ADDENDUM 1 TO BID #AZA 101103

PARTIAL MODERNIZATION

JAMES MADISON ELEMENTARY SCHOOL
1510 S. Nutwood Street, Anaheim, CA 92804

ADDENDUM 1 – James Madison ES Modernization

SK-1 Item 7c Exterior furred wall for conduits (Plan)

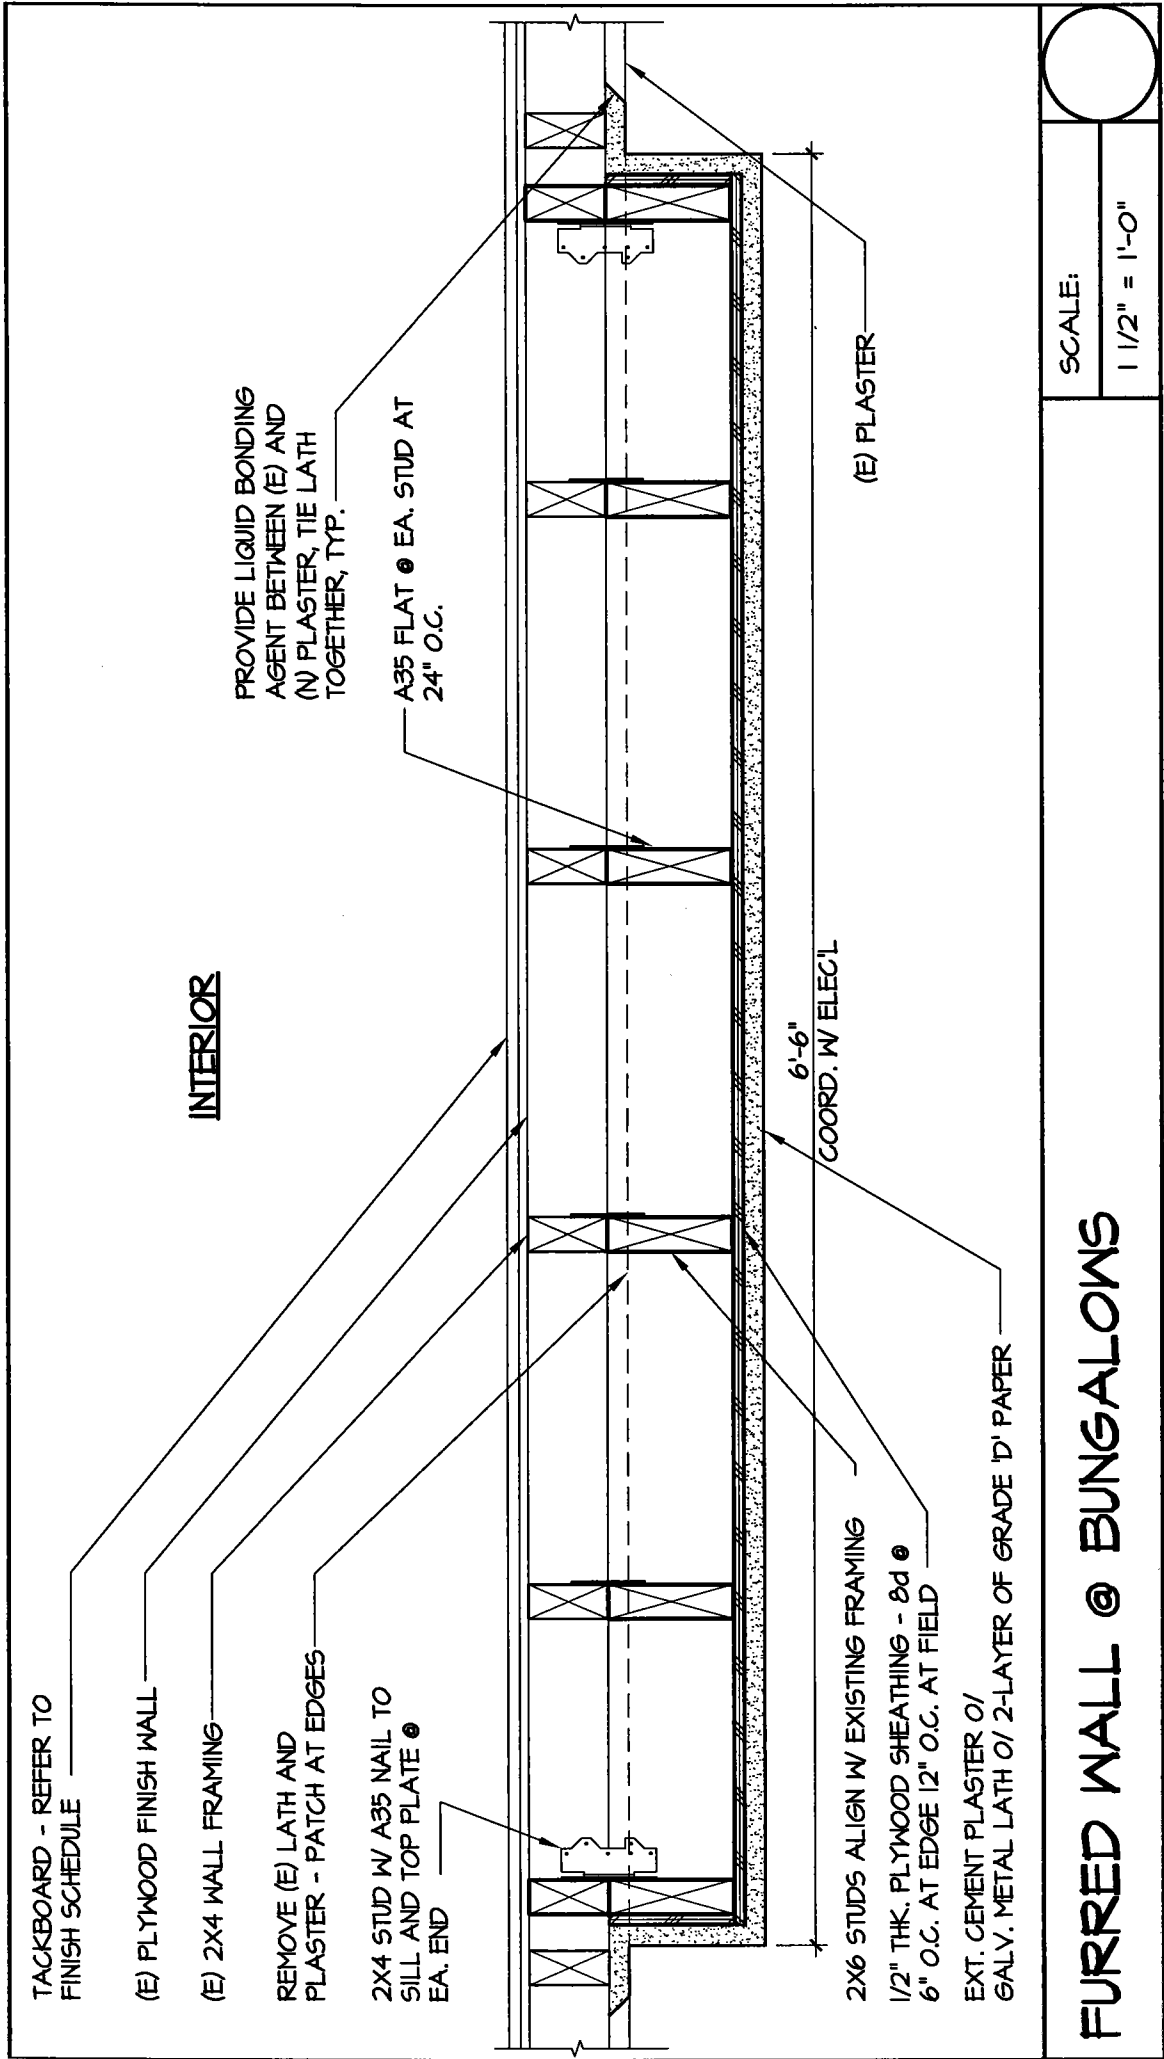
- c. Plans #1 & 2 – At the new surface mounted electrical panels and conduits located on the exterior side of the wall (south side of bungalow D and north side of bungalow E install a furred wall on the exterior side of the building to enclose the exposed conduits and panels. Paint panels to match adjacent finish and caulk around sides of all panels. (See Sk-1 thru SK-3).

FURRED WALL @ BUNGALOWS

A35 FLAT @ 24" O.C.

(N) 2X6 @ 16" O.C.

1/2" THK. PLYWOOD SHEATHING, Ed @ 6" O.C. EDGES

SK-4 Item 15a Water Heater anchorage detail 13/A10.5

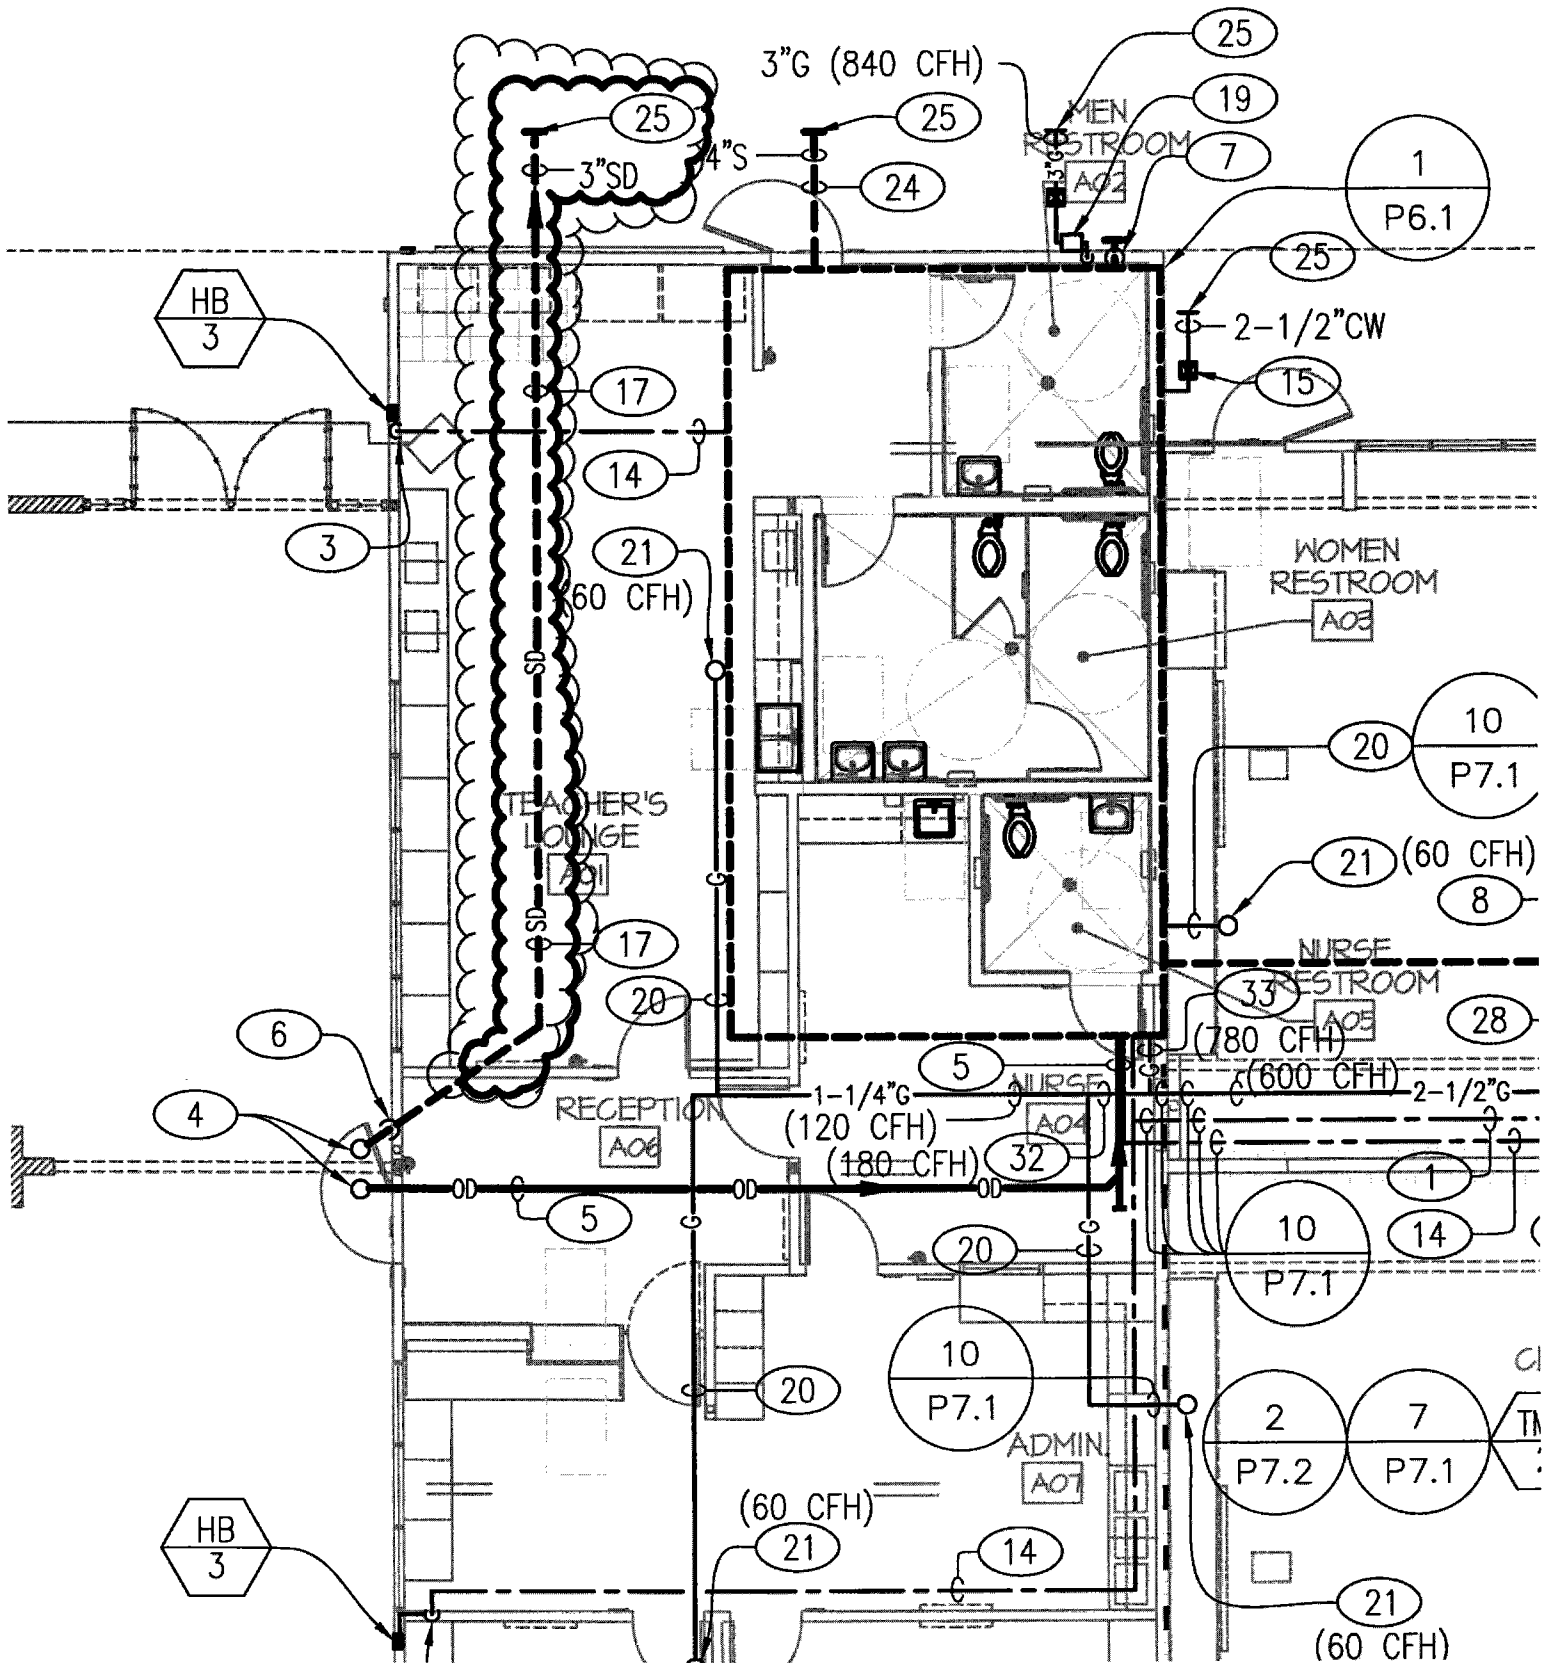
- II. Under section ‘Wood Paneling, Trim, and Skirting – Relocables’ add “Skirting @ Bungalows”.
15. Sheet A10.5 ‘Typical Details’
 - a. Detail #13 ‘Floor Mounted Water Heater Base’ – Detail added. (See SK-4)

SK-6 Item 17a Revised u.g. storm drain 1/P1.1

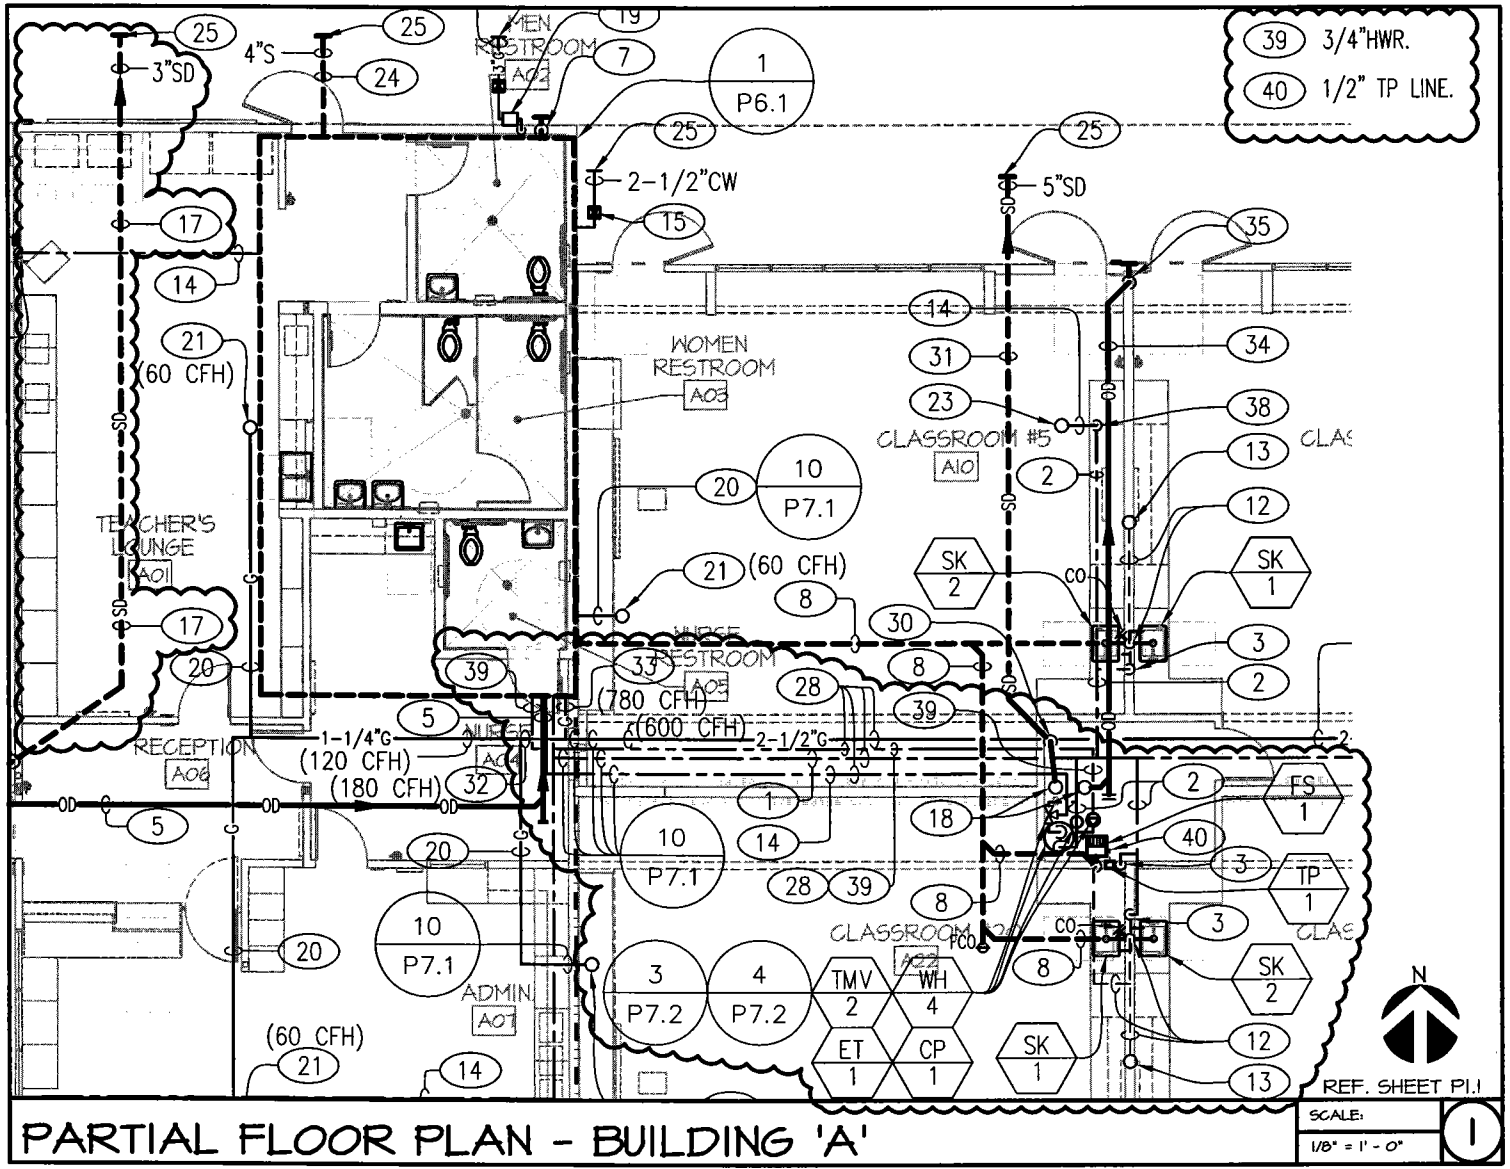
17. Sheets P1.1 Floor Plans – Buildings ‘A’ & ‘B’
 - a. Underground stormdrain line has been relocated east. (See SK-6)
 - b. At Storage Rm A23 water heater WH/1 has been replaced with water heater WH/4. (See SK-7)

SK-7 Item 17b&c New water heater WH/4 1/P1.1

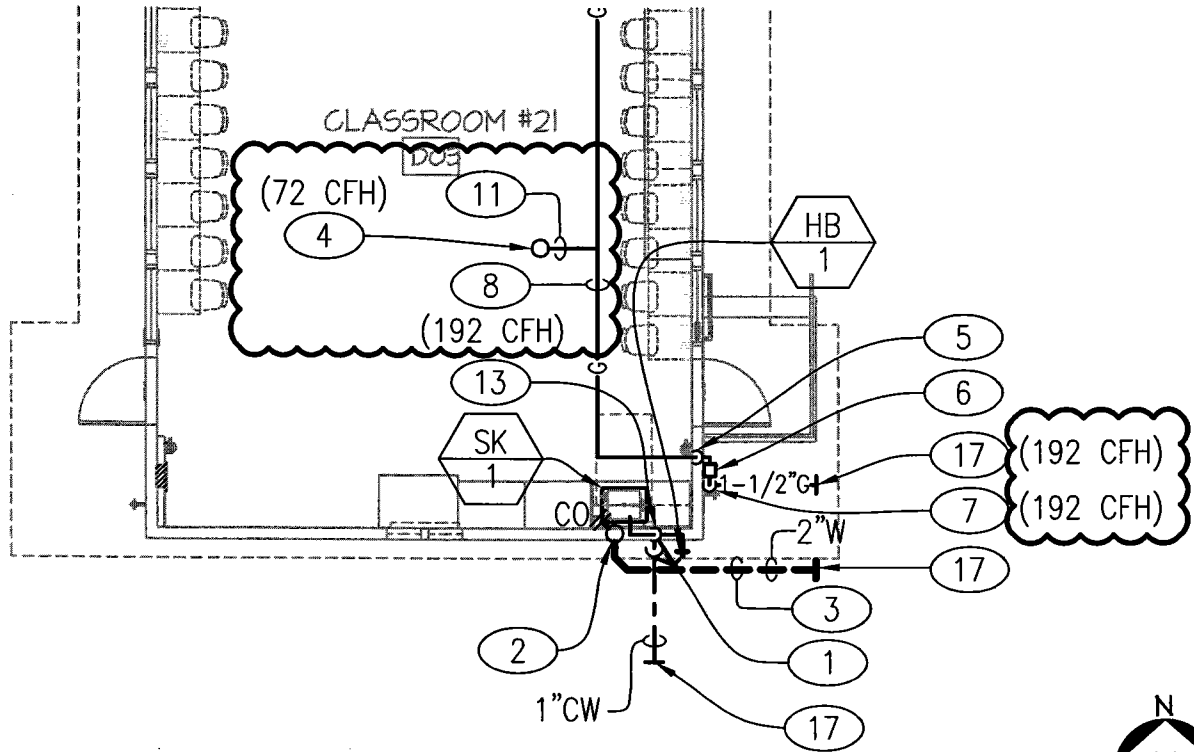
- c. At Storage Rm A23 new floor sink FS/1 added (See SK-7).
18. Sheets P1.3 Floor Plans – Buildings ‘D’ & ‘E’
 - a. Plan #1 – Gasline at classroom #21 (D03) revised (See SK-8)

PARTIAL ROOF PLAN - BUILDING 'D'

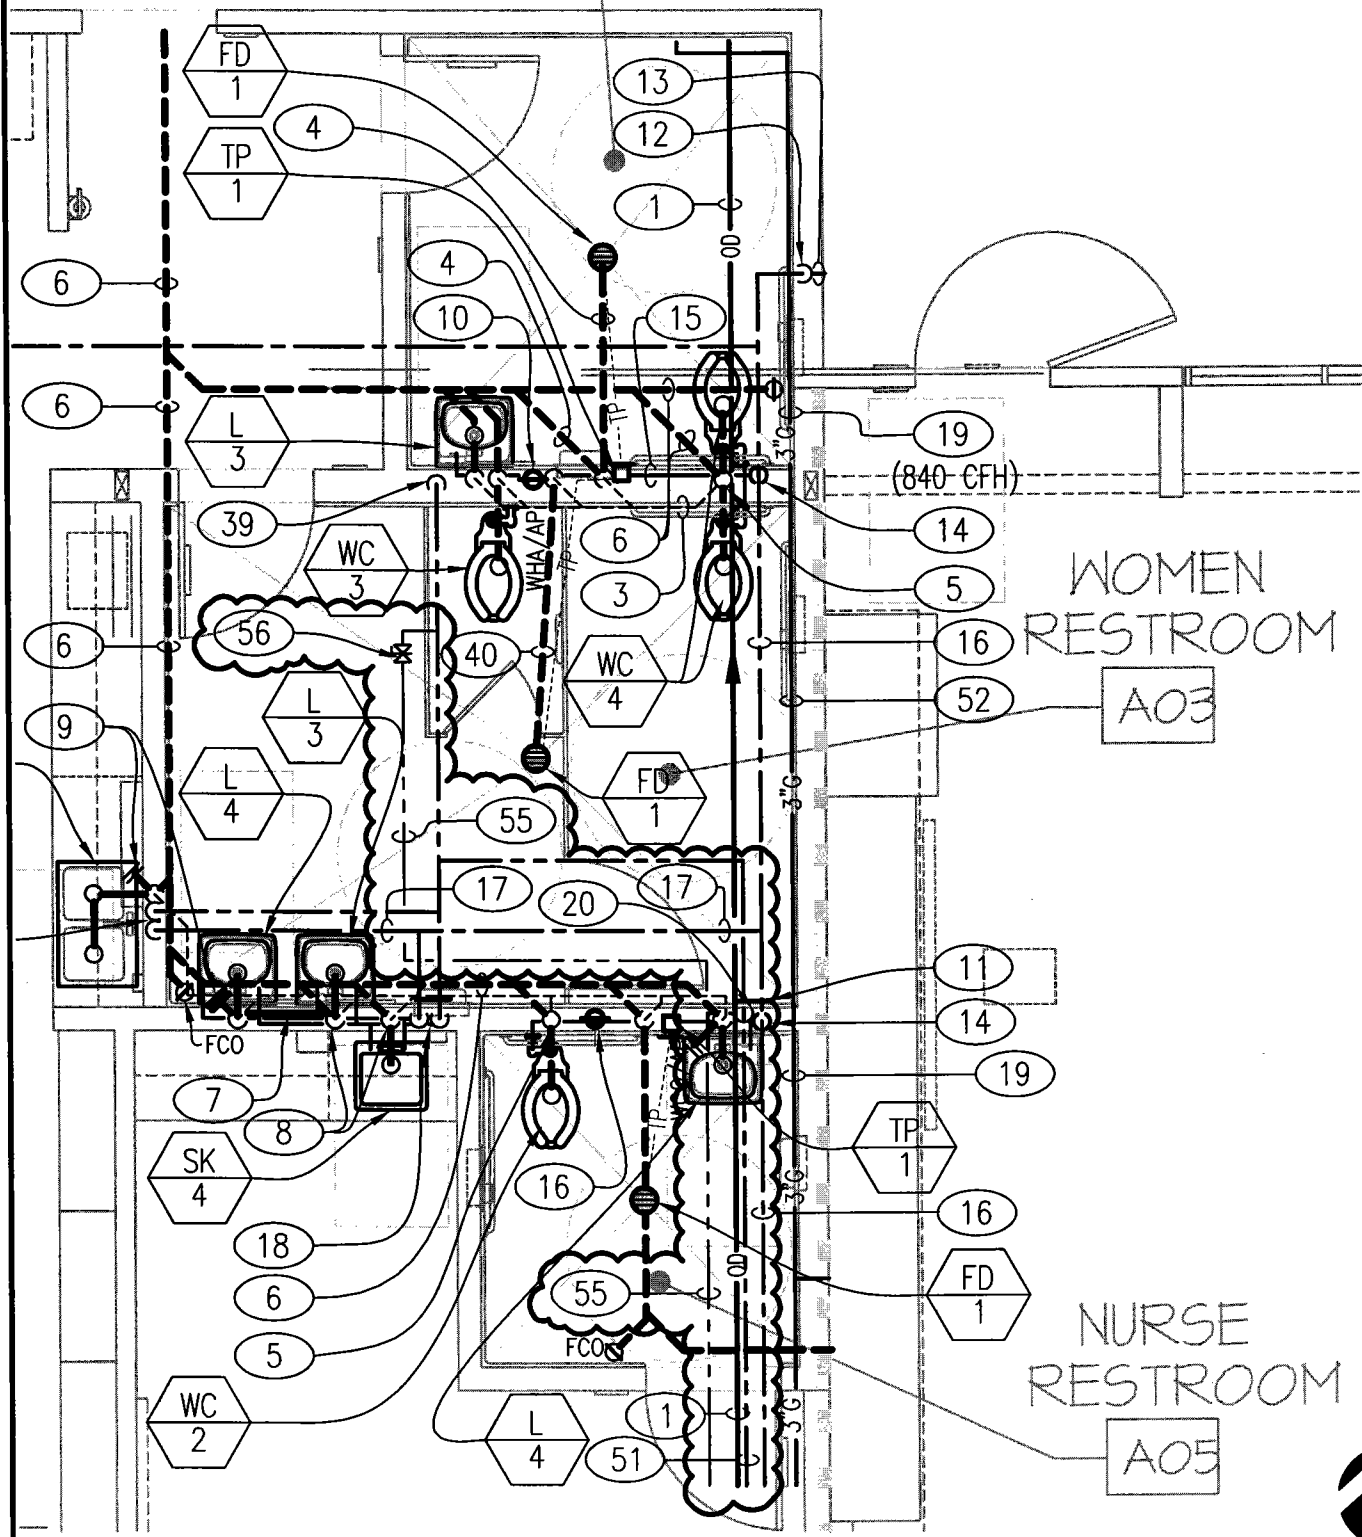
19. Sheets P3.3 Roof Plans – Buildings ‘D’ & ‘E’
 - a. Plan #1 – Gasline at classroom #21 (D03) at roof revised (See SK-9)
20. Sheets P6.1 Enlarged Restroom Floor Plans
